PROJECT: STBG-2906-00(008)/110153301 - Union

Emergency Slide Repair on SR 178 approximately 0.66 miles south of CR 121, known as Federal Aid Project No. STBG-2906-00(008) / 110153301 in Union County.

SECTION 904 – NOTICE TO BIDDERS NO. 8055

SUBJECT: Scope of Work

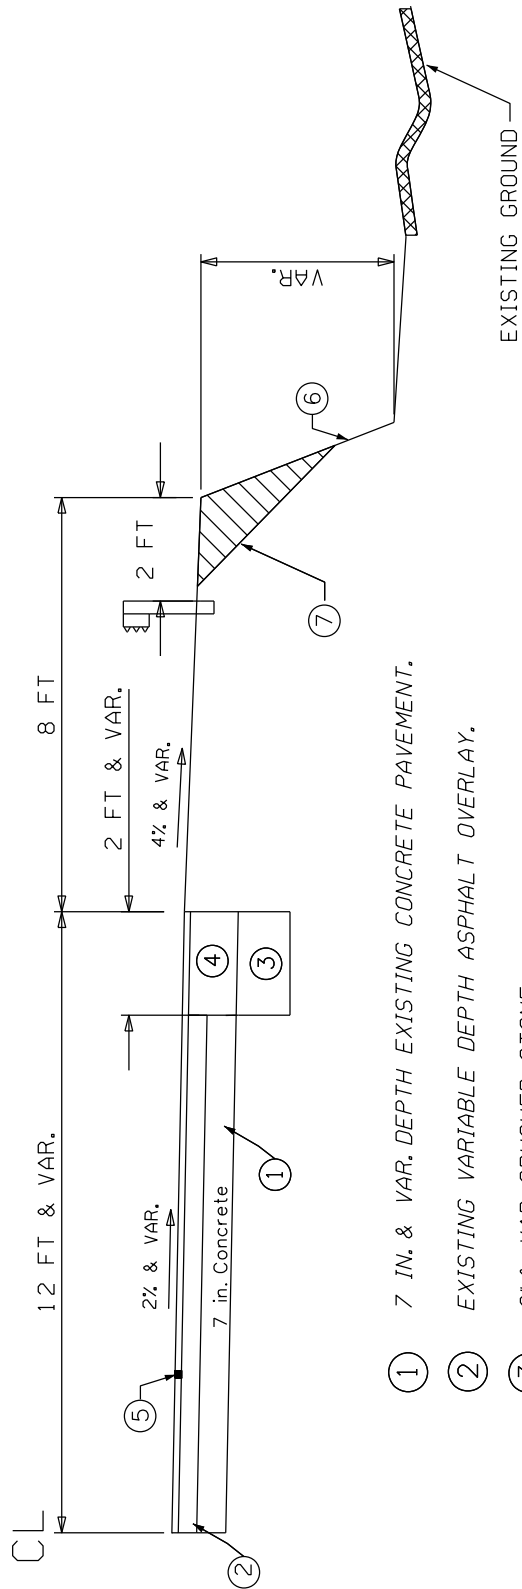
The Note “PRELIMINARY NOT FOR CONSTRUCTION” in the attached drawings was included in error and shall be disregarded.
